CITY OF HOBART

Special City Planning Committee Meeting

2.1.1 354 MACQUARIE STREET, SOUTH HOBART - PARTIAL DEMOLITION AND EXTENSION PLN-20-40 - FILE REF: F20/112584

**APPLICATION UNDER HOBART INTERIM PLANNING SCHEME 2015**

Figure 4: The street facing elevation of the proposal.

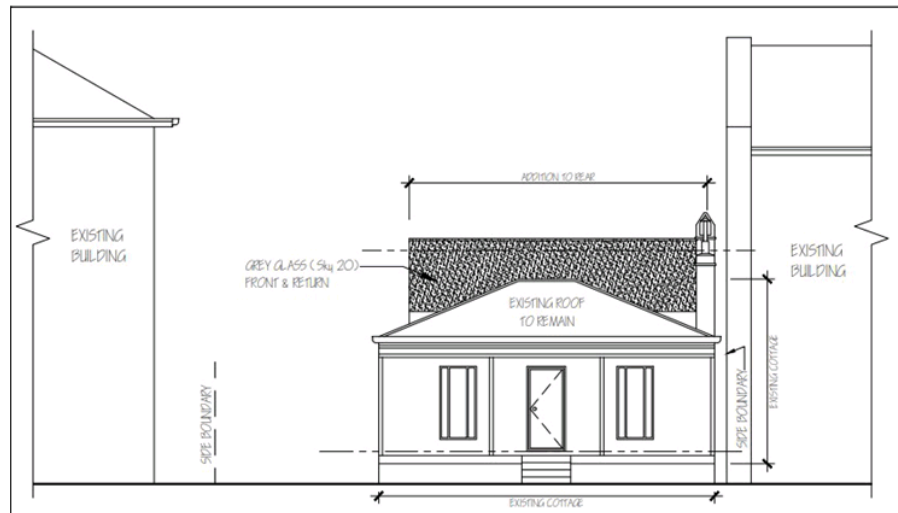
With regard to the proposed development, it is considered that the cottage as existing has almost entirely retained its general traditional form, silhouette and scale other than some later unfortunate limited bay windows added to the front elevation. The proposed extension would in contrast remove a section of the original roof fabric, and fundamentally alter the appearance of the cottage, especially at roof level. It is noted that the application does not provide any rationale or set out potential 'exceptional circumstances' as set out above.

The increase in overall bulk would be considerable, and would be particularly notable given both the modest scale of the original cottage. The architectural response would appear to have had no regard for the traditional form of the roof or the cottage and would fail to reflect or work alongside the style, dimensions or materials of the original cottage, or indeed of any of the properties within the wider Heritage Precinct.

Importantly, the proposed extension would be highly visible from the street and increase the height and significantly alter the overall appearance of the original cottage. It would create a highly unsympathetic roof form and form the context against which the existing hipped roof would be viewed, whilst also having a significant impact upon the wider group of buildings in which the cottage stands despite being set back from the street and partially obscured by the bulk of neighbouring buildings. It is considered that the impact would be particularly notable during dusk to morning hours when any internal lights are on and therefore likely to create a strong halo effect given the fully glazed elevations facing onto the street.

Overall, it is considered that the proposal would create a highly inappropriate two storey rear addition to a modest single storey Georgian cottage that would fail to represent the original traditional characteristics, scale, bulk, form, proportions and building materials of the original cottage, distorting its modest background and thus its role in contributing to the historical and cultural importance of the Heritage Precinct.
